Copperton Planning Commission

Copperton Planning Commission Meeting September 10, 2024

File # PUD2024-001214

Planned Unit Development Summary and Recommendation

Site Plan

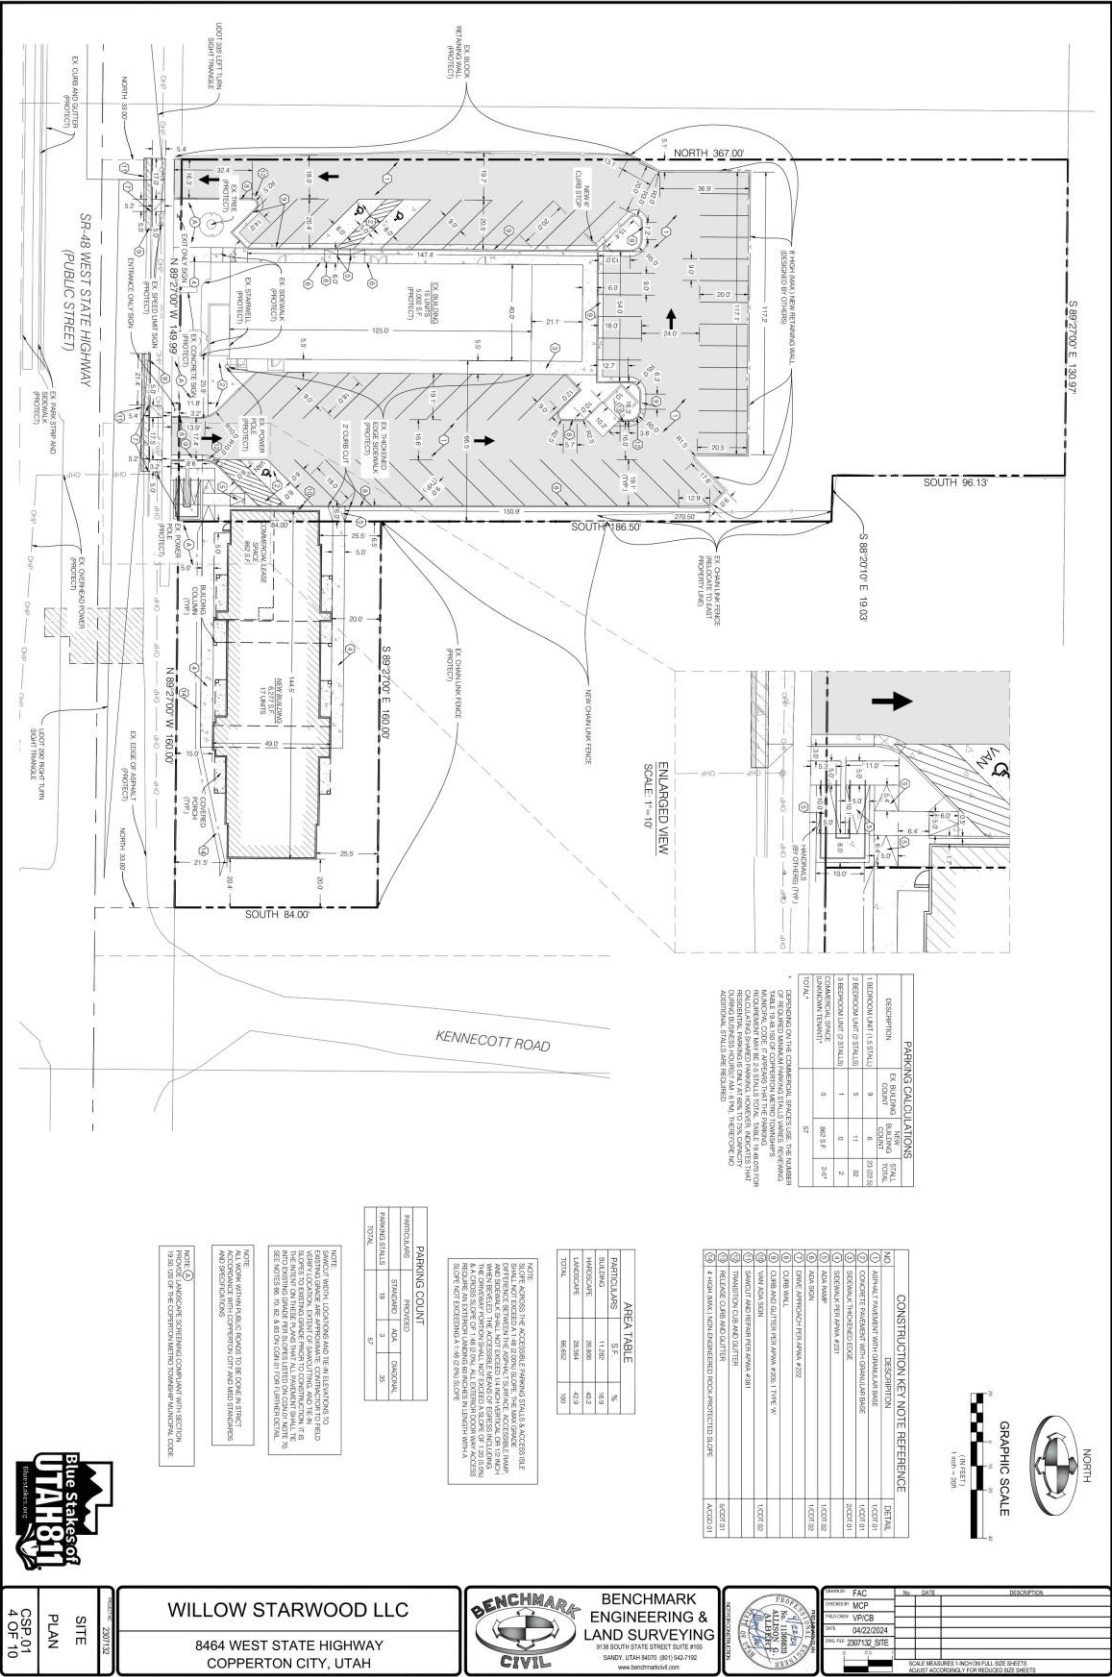
Referring to the site plan, there appears to be no parking between the buildings and the street.

Referring to the site plan, we find that the front yard of the PUD meets the 15' front yard setback and 20' rear yard setback requirement as stated above.

On the southeast corner of the parking lot which I have marked with the red square, does that intend on being part of the handicapped parking spot to the south of it? The minimum width required for regular parking stalls is 9 feet.

Elevations

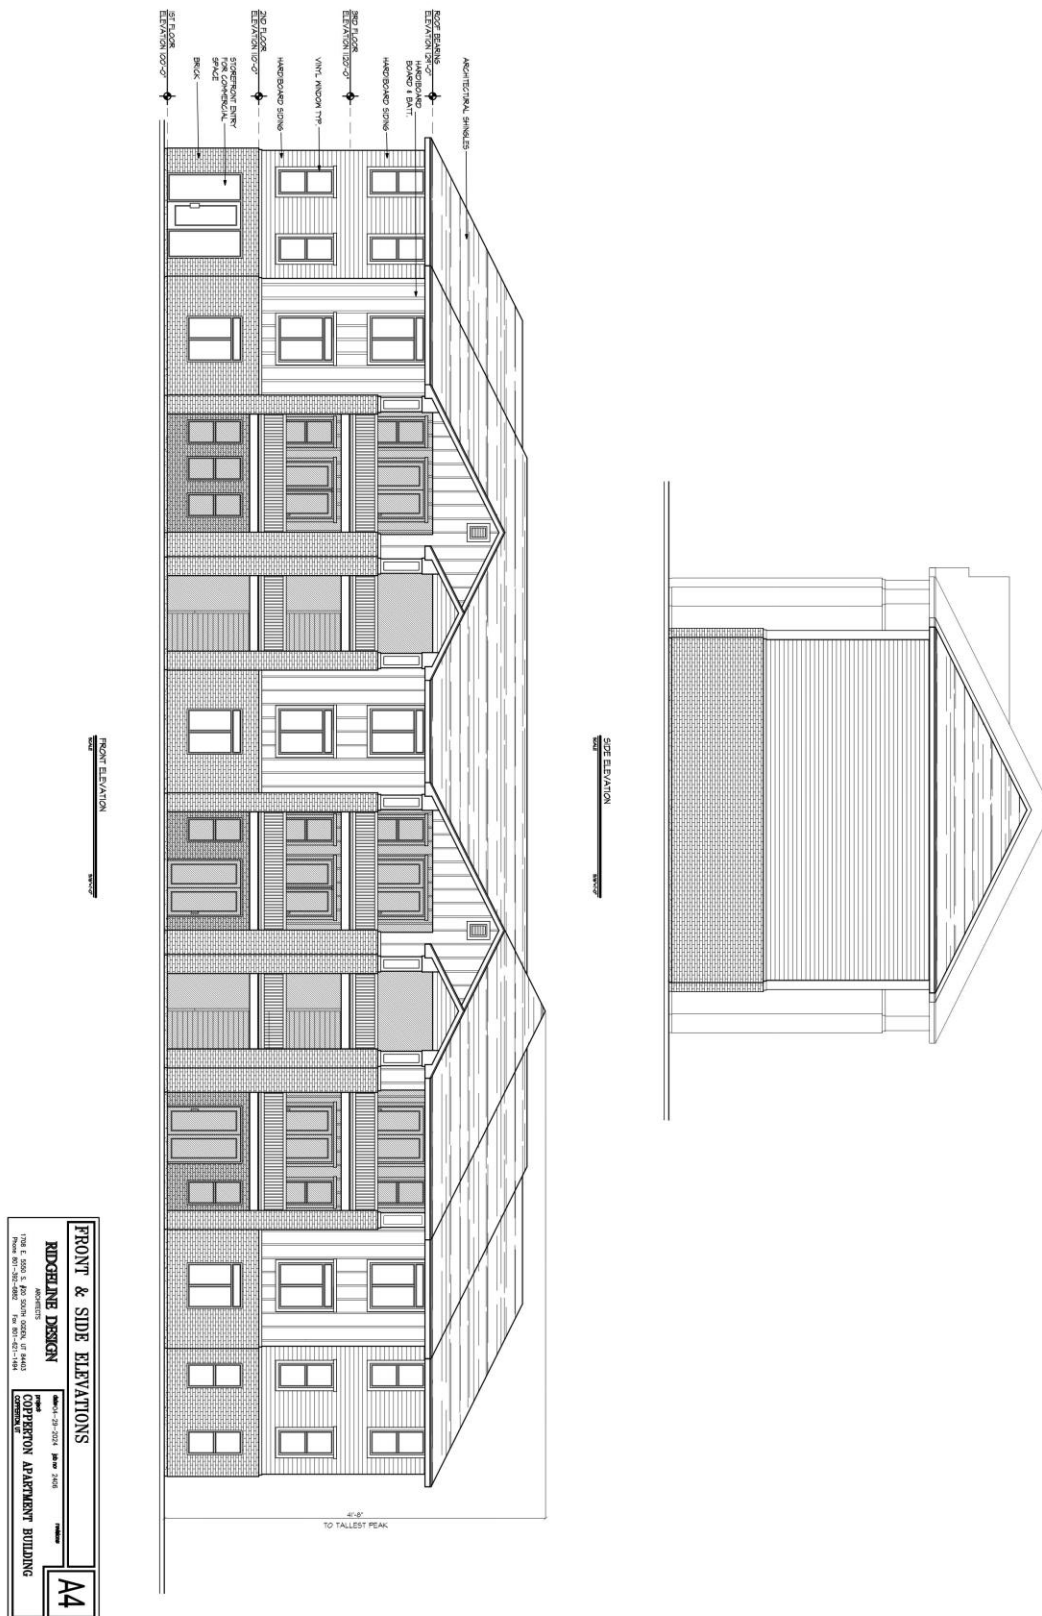
The C-2 zone has a maximum height of 35 feet, measured from the lowest point on original ground surface to a point midway between the peak and the top plate of the wall. The building elevations submitted comply with the C-2 height limit.

The one designated commercial unit of this PUD meets the above criteria. We find that the windows make up 50% of the street-facing façade as it features a glass door and large windows. The entrance also faces the street.

Landscaping Plan

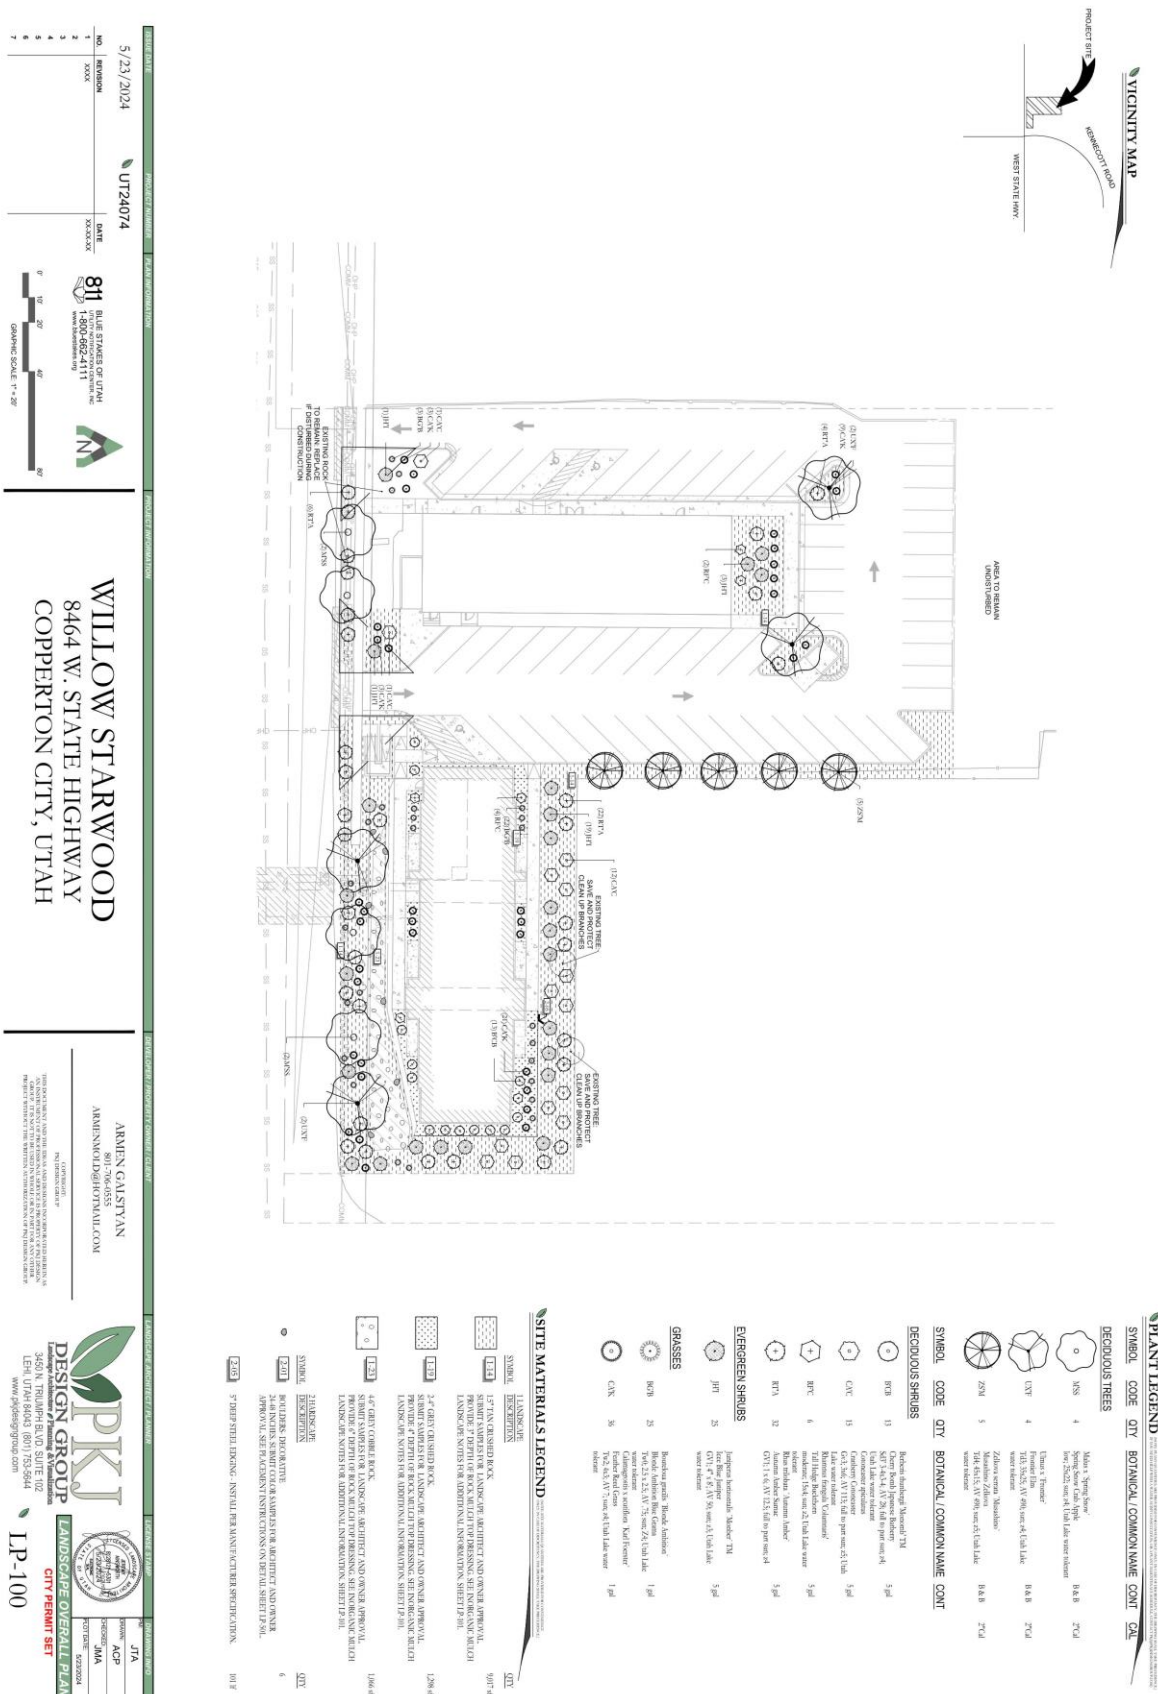
We find that the landscaping as shown in the landscaping plan complies with landscaping standards as stated in Chapter 19.50 of the Copperton Municipal Code.
